**RELEASED FOR  
 FABRICATION / INSTALLATION**  
 PPPL Drafting:

Oak Ridge National Laboratory managed for the DEPARTMENT OF ENERGY under U.S. GOVERNMENT contract DE-AC05-00OR22725 UT-BATTELLE, LLC, Oak Ridge, Tennessee PROJECT NAME						
NATIONAL COMPACT STELLERATOR EXPERIMENT VACUUM VESSEL PERIOD INSPECTION AND LEAK CHECK ASSEMBLY						
VERSION NO.	PLANT	BLDG	FL	SHT OF	TYPE	CLASS
5	X-10	5700	3	2 19	A	U
RELEASE LEVEL		SE120-004			REV	
Fabrication					2

TYPICAL PORT 2A AND 2B SECTION PORT02-PORT02

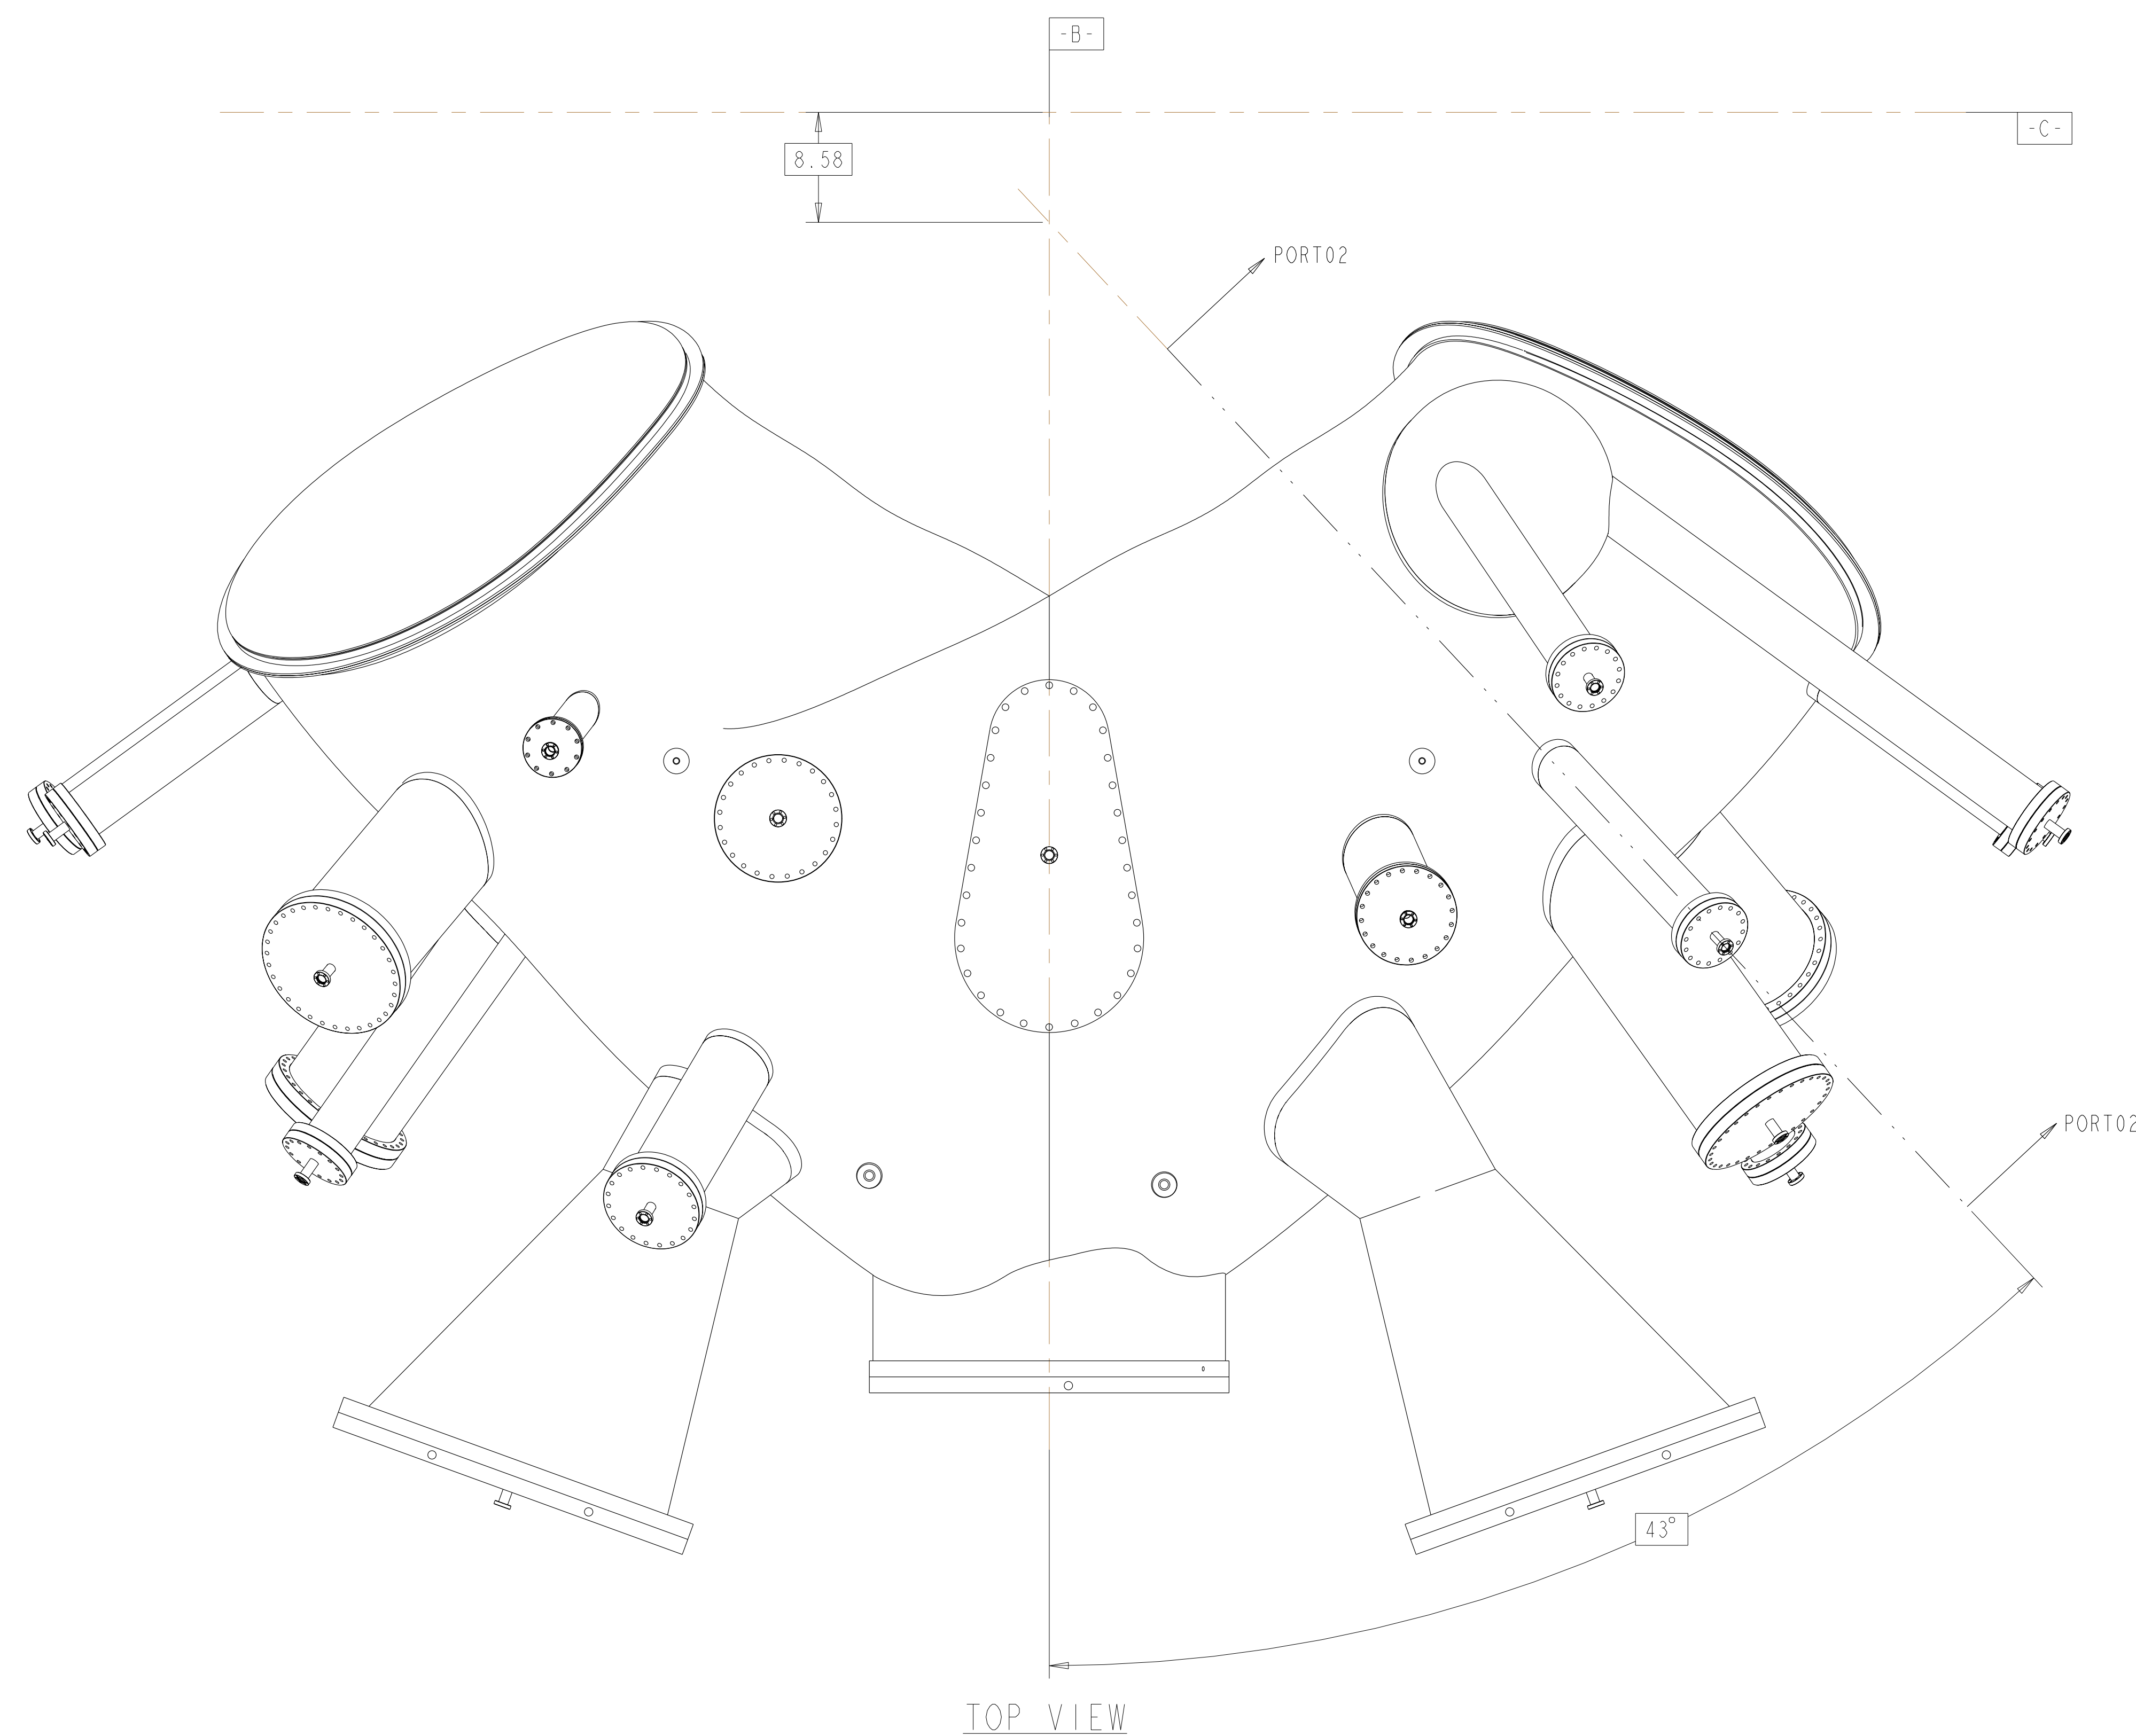
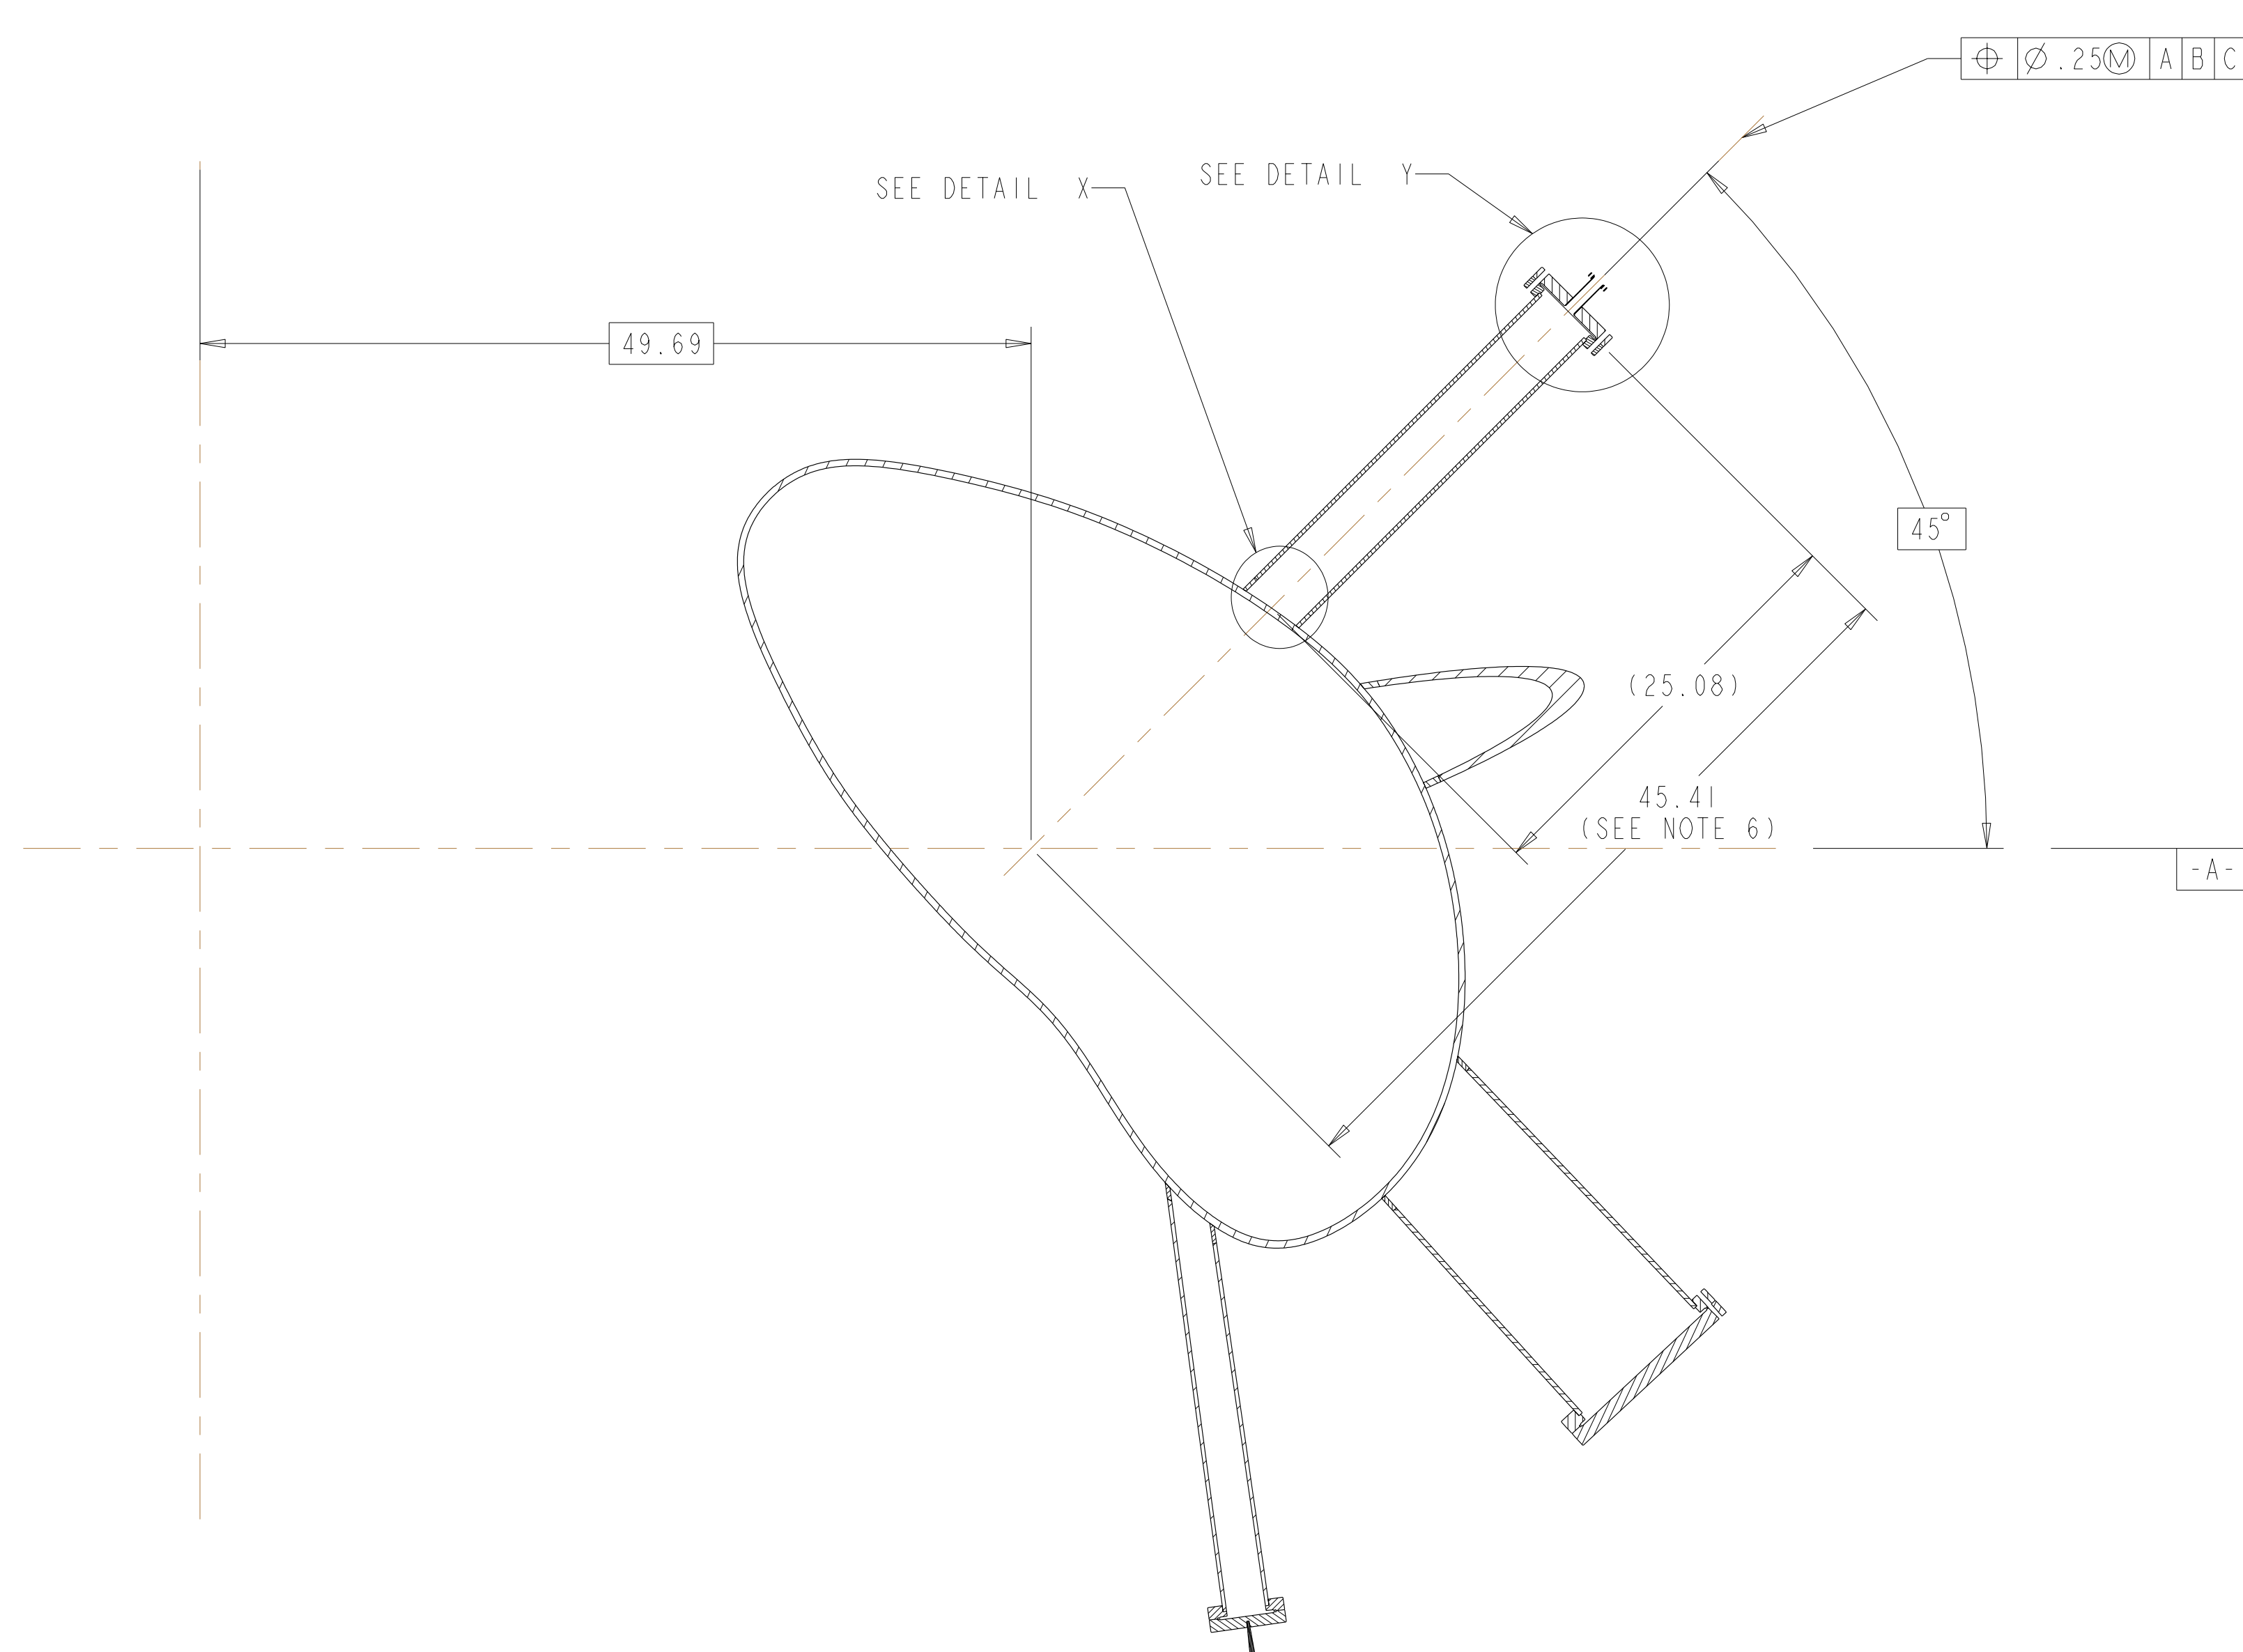
**Rev 2-e: ECN-5021 (RFD-12-017) approved alternate methods for welding the port extensions to the VVSA (See ECN-5021 for details). - Only applicable to VVSA #3 - VVSA #1 and #2 covered by NCR 19464.**

**ECN-5082.** Requirement originally included grooves to facilitate leak checking by vendor. However, vendor elected another means of leak checking and therefore the grooves are no longer required. Specifically, this ECN eliminated the leak checking groove on SE121-014 (Rev 1-c) and SE1221-091 (Rev 0-a). Additionally, this ECN added a missing weld symbol to SE121-004 (Sheets 4 through 19) for joining the port extensions to the vessel (Rev 2-d).  
(See ECN-5082 for details)
